Proposal for amendments to working document GRSG/2025/51 (Draft Proposal for a new UN Regulation on the approval of a vehicle type with an advanced driver distraction warning system)

I. Proposal for Draft Proposal for a new UN Regulation on the approval of a vehicle type with an advanced driver distraction warning system

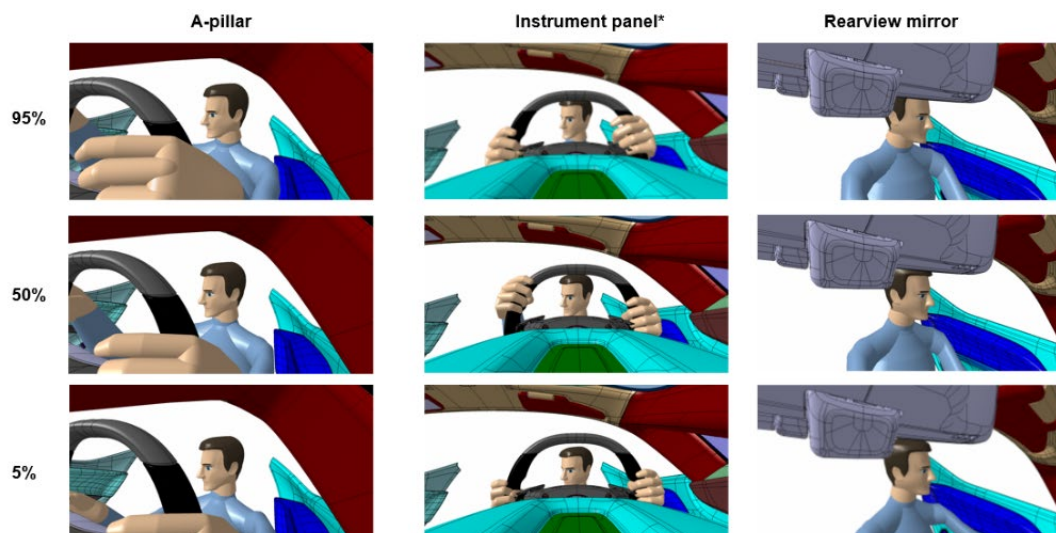
1.1. This Regulation applies to vehicles of category M and N **where the "R" point of the driver seat is more than 450 mm from ground level.**

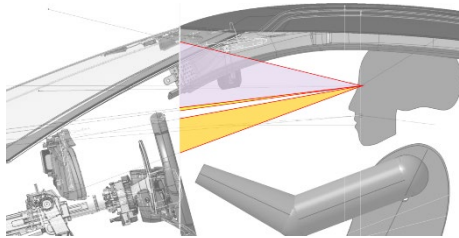
2. At-the-date, ADDW systems are mainly based on a camera sensor able to monitor the driver's gaze. In order to fulfil ADDW performance/testing requirements, camera-system should be able to monitor **both driver's eyes**. Considering the peculiar cabin architecture of high performance vehicles (e.g. thinner and very tilted "A" pillar, smaller field of view, low volume cabin compartment), the following images show cases where the gaze of the driver, looking at the boundaries of the distraction zone as define by the GRSG/2025/51 proposal, is not fully visible (i.e. both driver's eyes) for most common camera-installation positions in

a car. This could lead to false positives, system unavailability. In addition, high-performance vehicles have smaller frontal field of vision compared to mass market vehicles. Therefore, a reduced frontal area to fit information inside central cluster leads to challenging installation of ADDW camera.
